Docket Number:	19-SPPE-01
Project Title:	Laurelwood Data Center (MECP I Santa Clara I, LLC)
TN #:	229959
Document Title:	Testimony of Robert Sarvey on the Initial Study
Description:	Robert Sarvey Testimony on Laurelwood Data Center ISMND
Filer:	Robert Sarvey
Organization:	Robert Sarvey
Submitter Role:	Intervenor
Submission Date:	10/3/2019 4:39:07 PM
Docketed Date:	10/3/2019

THE PROJECT DOES NOT QUALIFY FOR A SMALL POWER PLANT EXCEPTION

Figure 5-1

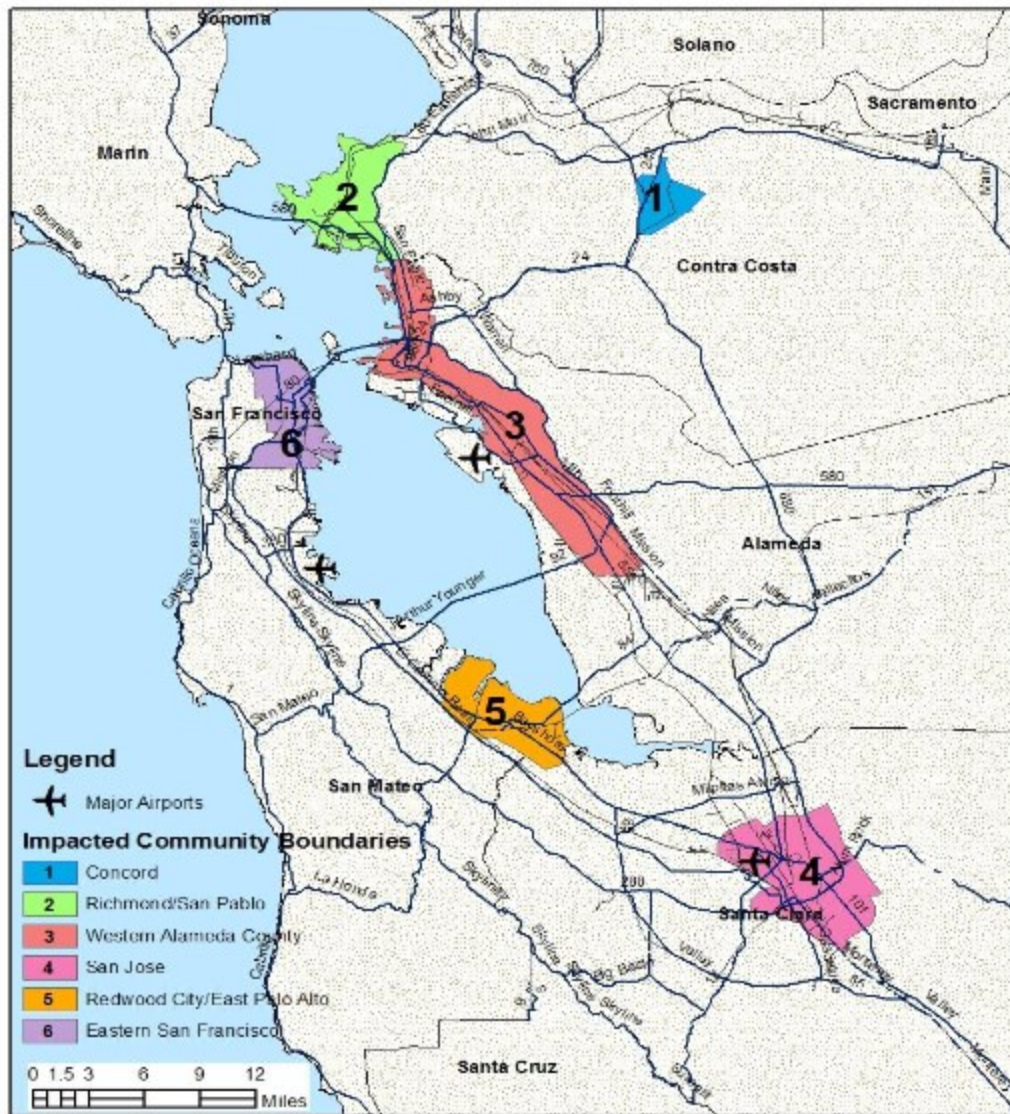
As the guidance document states, "*in all areas, but especially within impacted communities identified under BAAQMD's CARE program, the Lead Agency is encouraged to develop and adopt a Community Risk Reduction Plan. To determine whether an impacted community is located in a jurisdiction, the Lead Agency should refer to Figure 5-1.*"

Despite these CEQA and BAAQMD requirements and the potential wildfire impacts, the initial study fails to conduct a cumulative impact analysis, even though this project is located in an area recognized by BAAQMD as a Community at Risk.

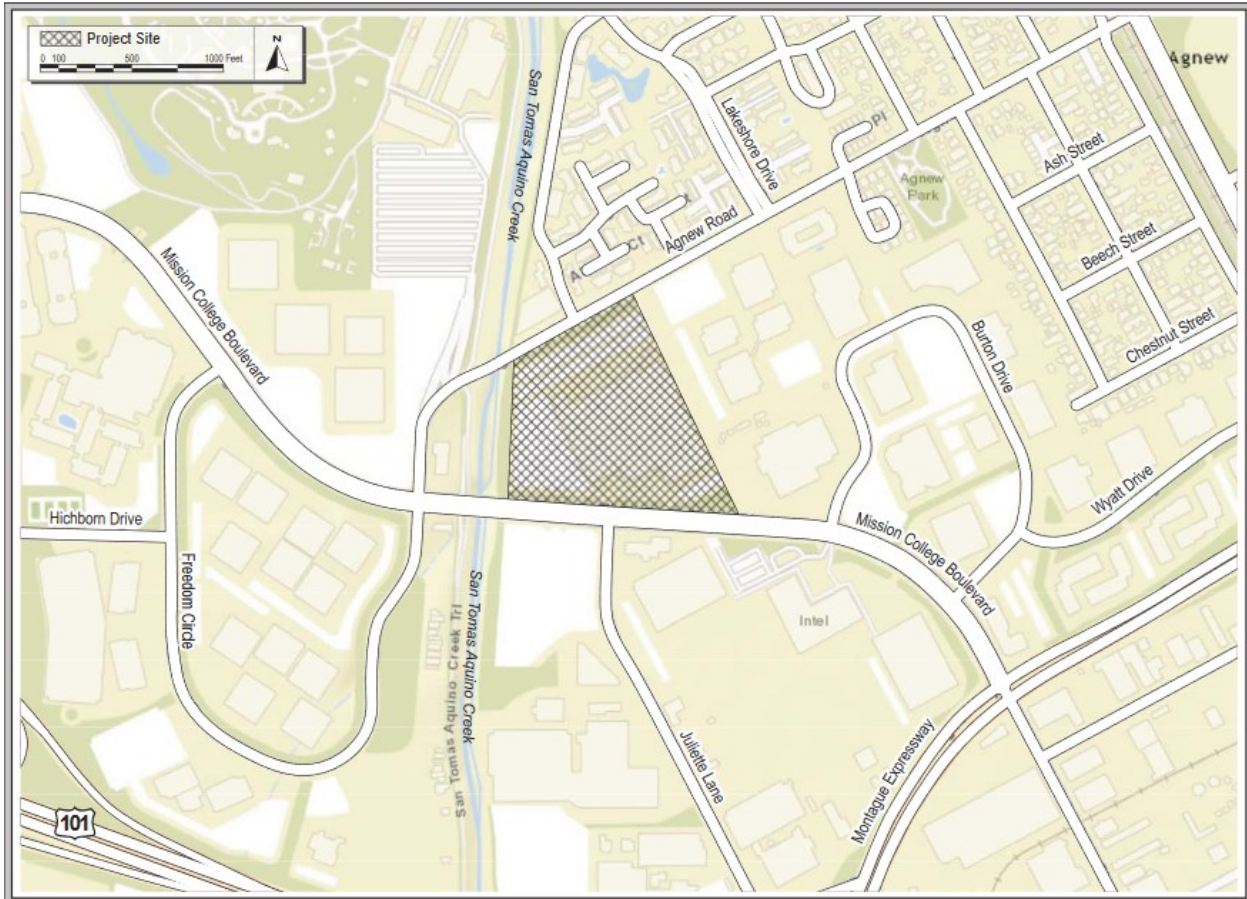
A new data center has been approved by the City of Santa Clara at 2305 Mission College Blvd. The 2305 Mission College Boulevard data center would employ 120 625-kW diesel-fueled engine generators located within a generator yard west of the data center building. The 120 emergency backup generators would each be tested once per month at full load for up to one hour. No more than 45 generators would be tested at any one time.⁸ The generators would provide 75 MW of backup power generation capacity. Diesel fuel for the generators will be stored in 24,10,000-gallon above ground tanks, with one tank located beneath each block of five generators.⁹ The existing improvements on the site would be demolished to allow for construction of the project. Demolition and construction activities would last approximately 15 months. The map below depicts its location.
